## ADDENDUM #01

ACES at CHASE

STATE PROJECT NO. 244-0044 MAG

6. **ALL Bidders** should review and incorporate the **attached Bulletin #1 dated December 16, 2025** prepared by **S/P+A** and their consultants. This Addendum includes:

7 WATER-TIGHT WALL SLEEVE  
SCALE: NONE

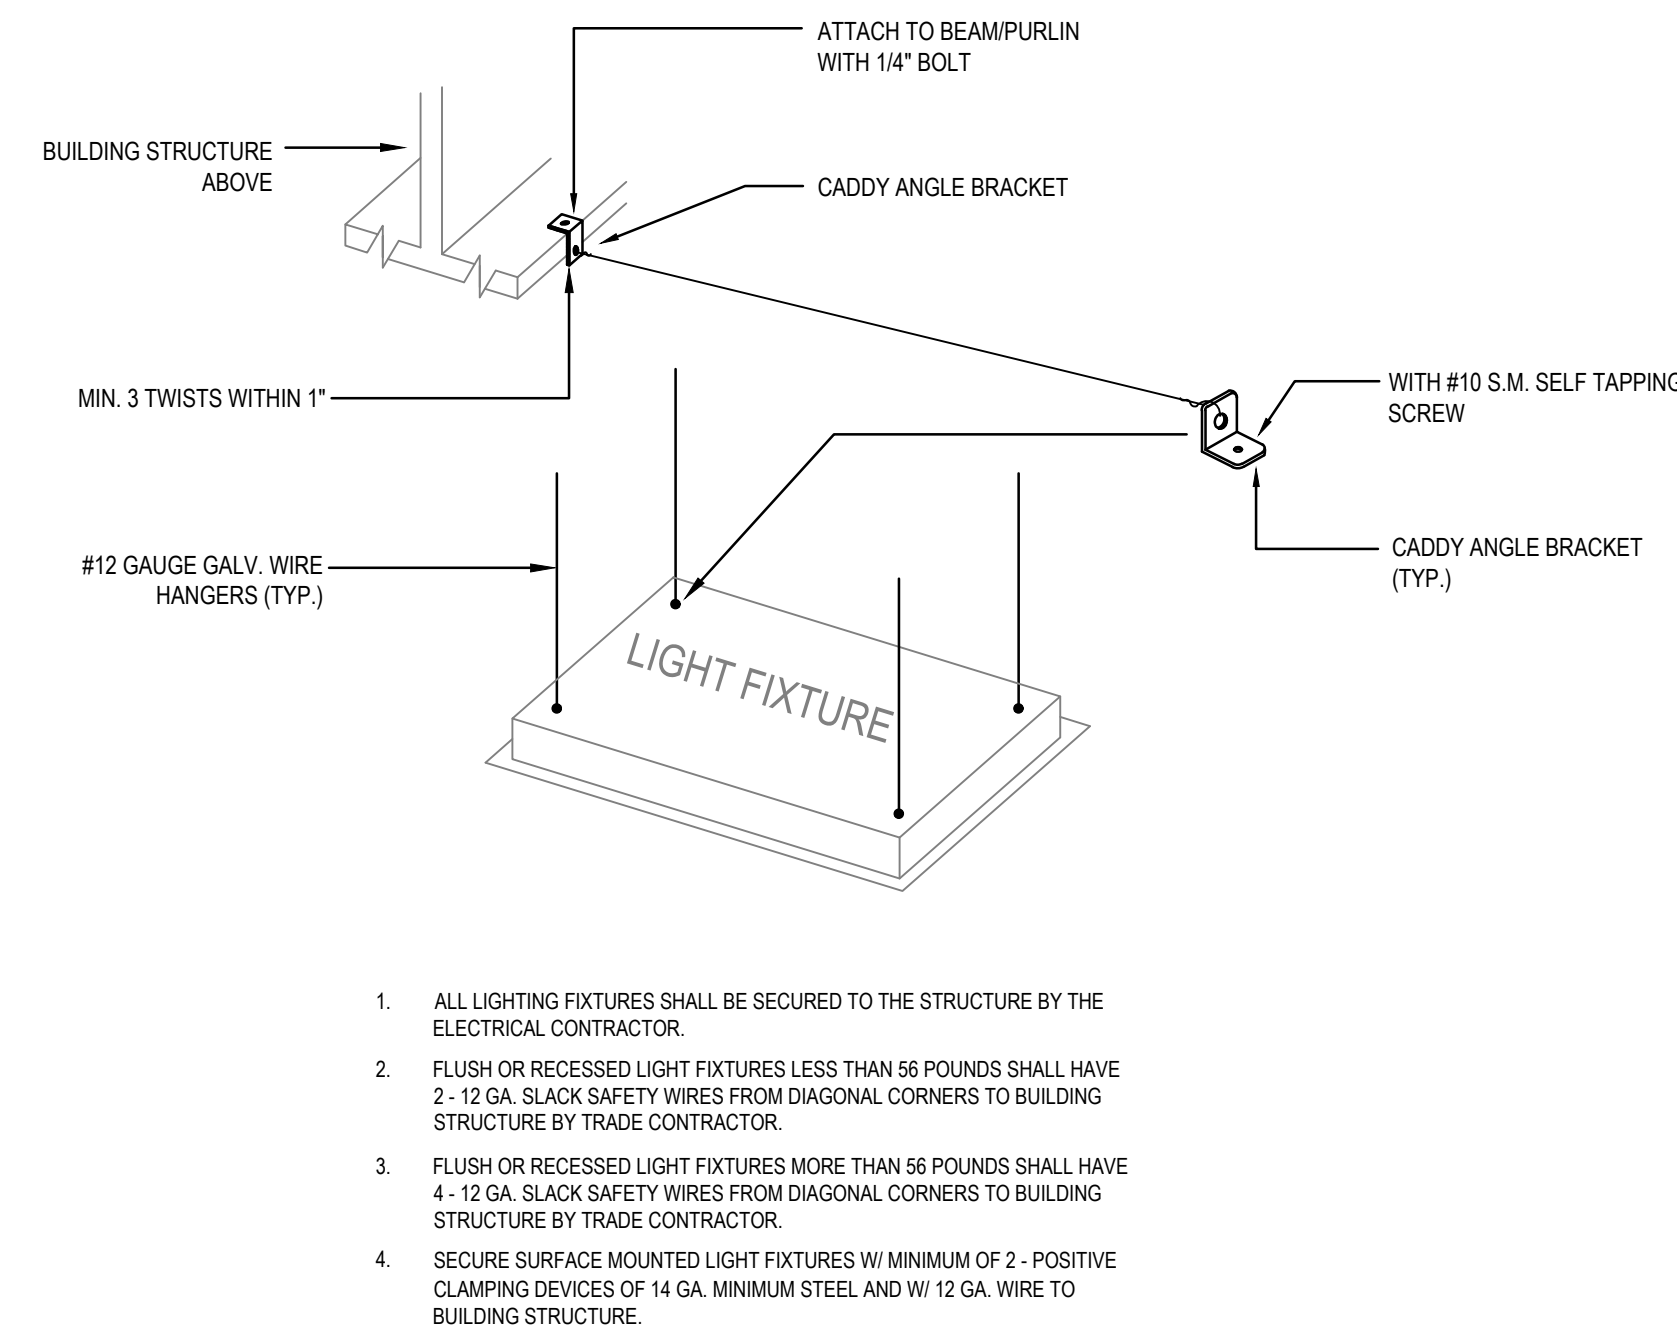
- E230-1 BUILDING 1 – THIRD LEVEL POWER PLAN *(Per Internal Review)*
    - E400-1 BUILDING 1 – DETAILS *(Per Cx)*
  - Building 2:
    - The following ELECTRICAL drawings have been deleted in their entirety. New drawings (4) have been added and are attached as part of this bulletin\*:

**E200-2**

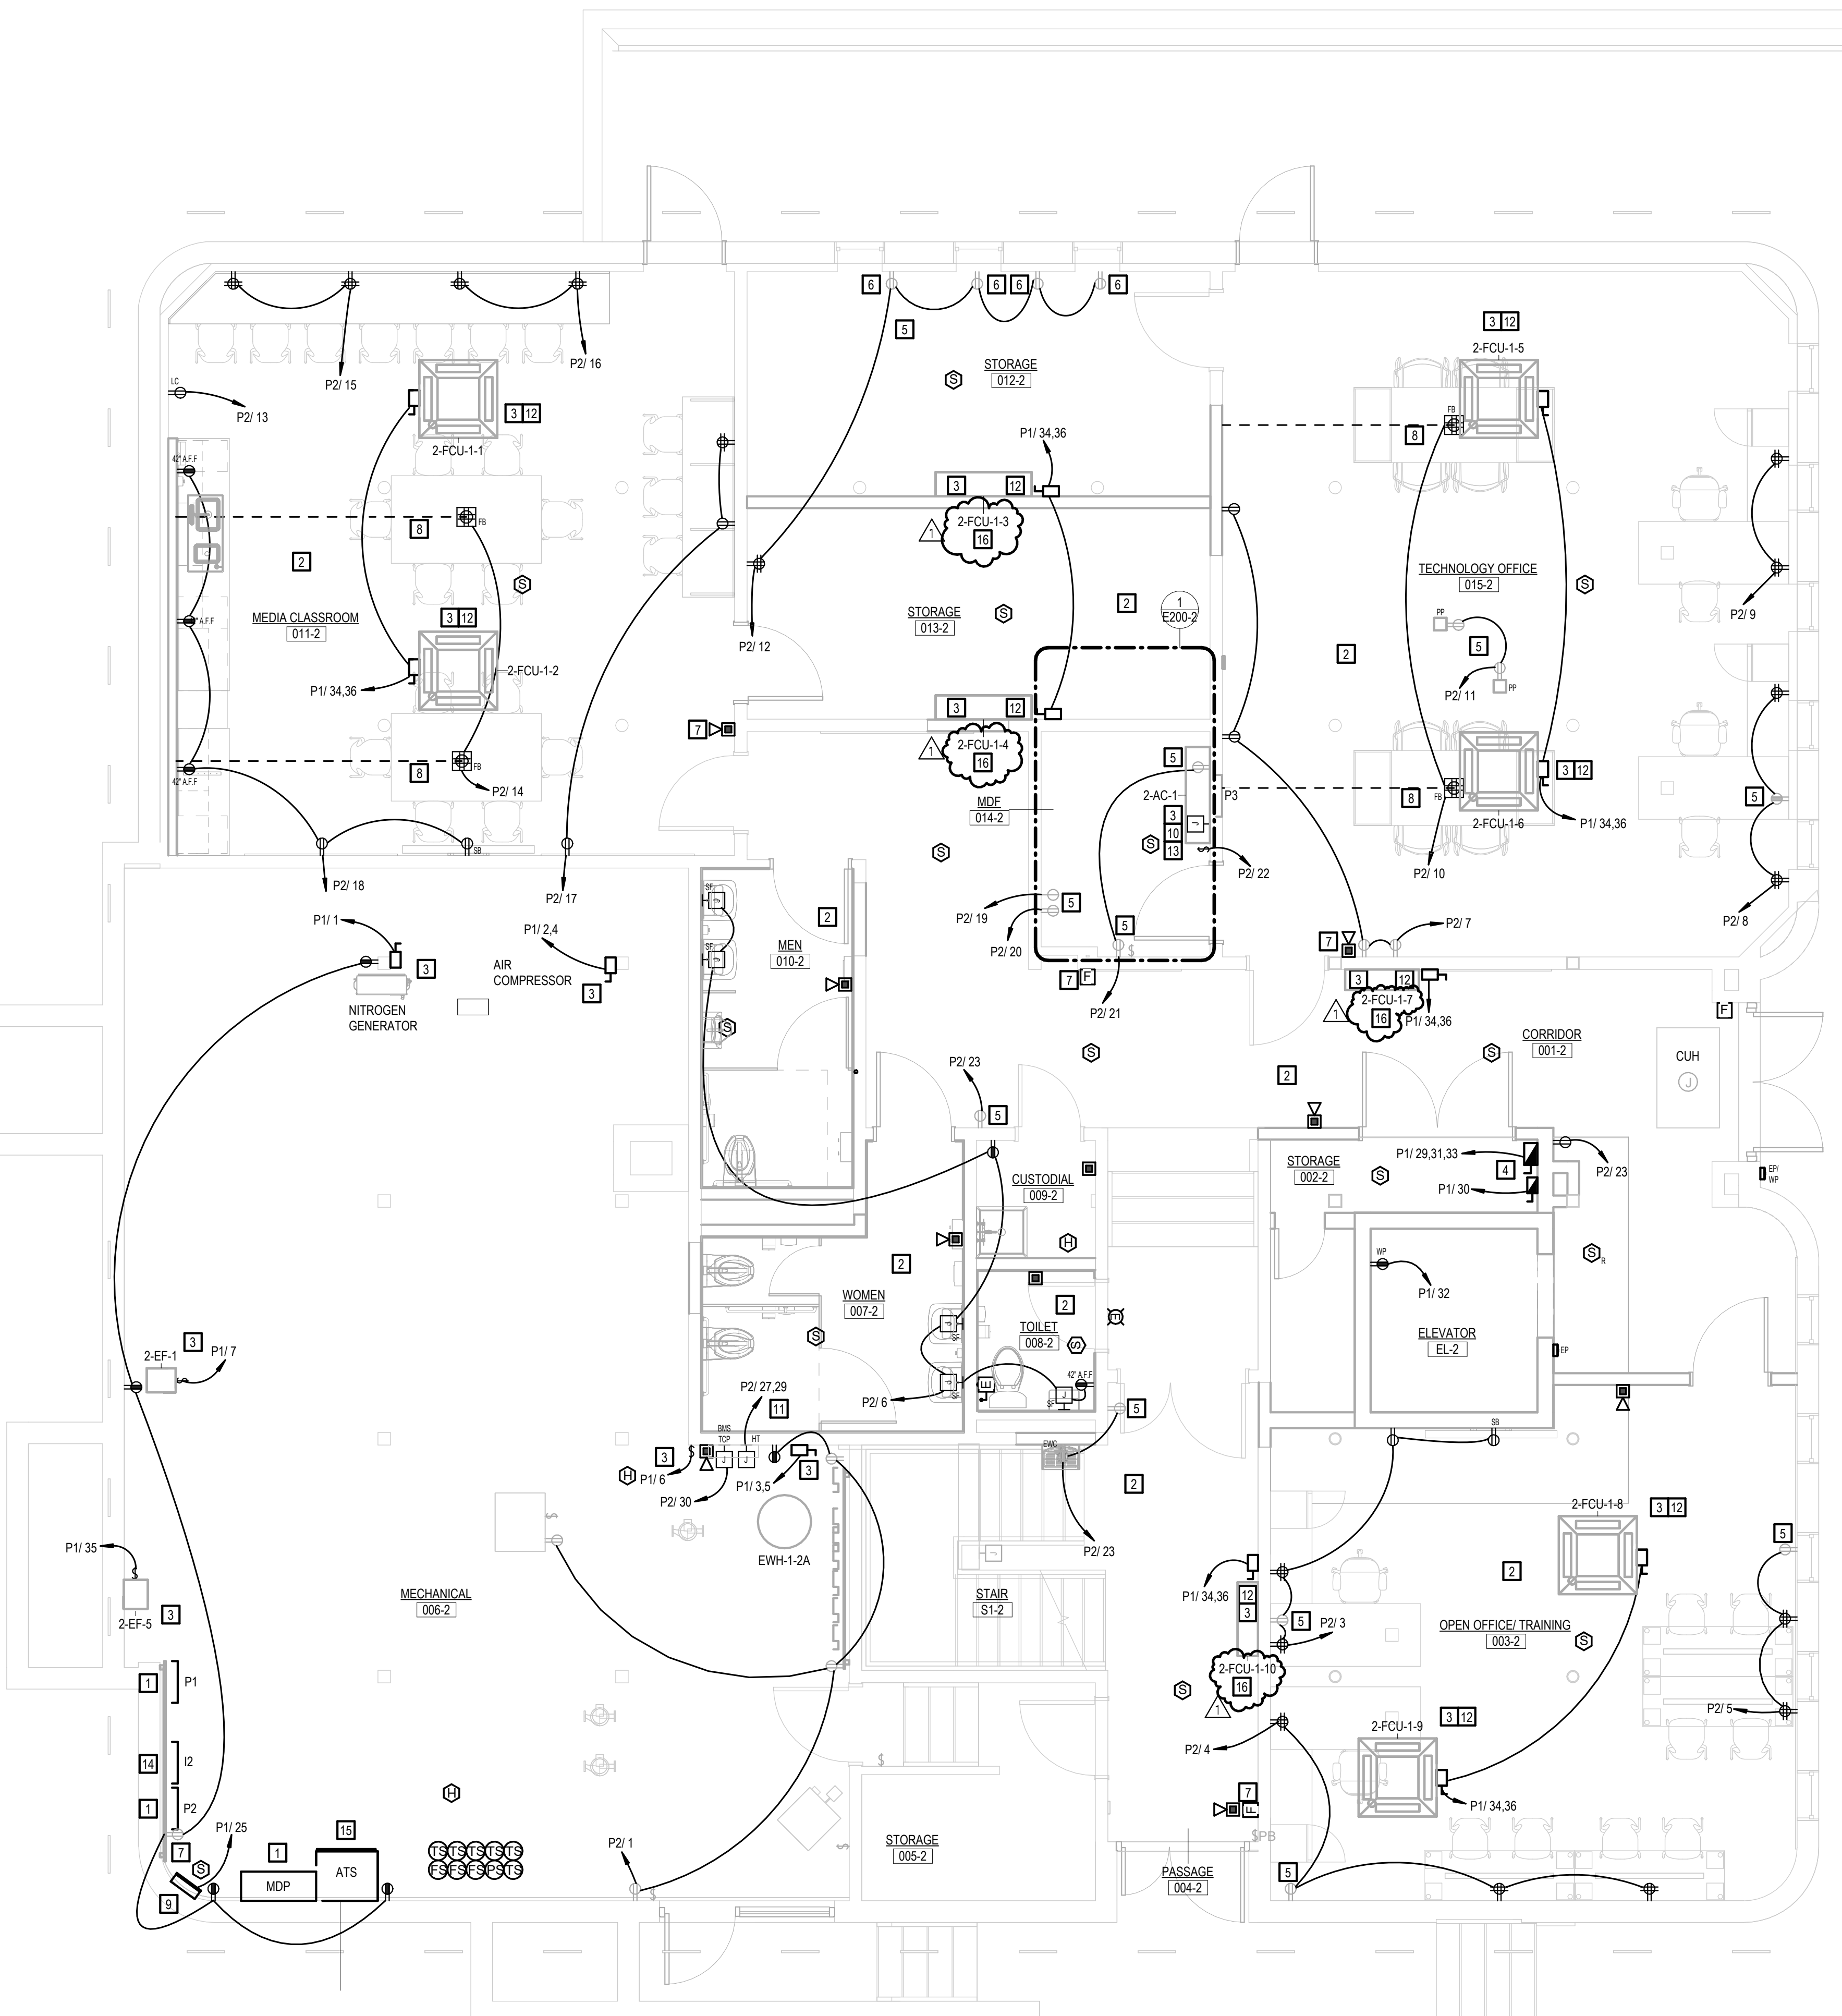
- E200-2 BUILDING 2 – LOWER LEVEL POWER PLAN – PART 'A' *(Per Internal Review)*
      - E210-2 BUILDING 2 – MAIN LEVEL POWER PLAN – PART 'A' *(Per Internal Review)*
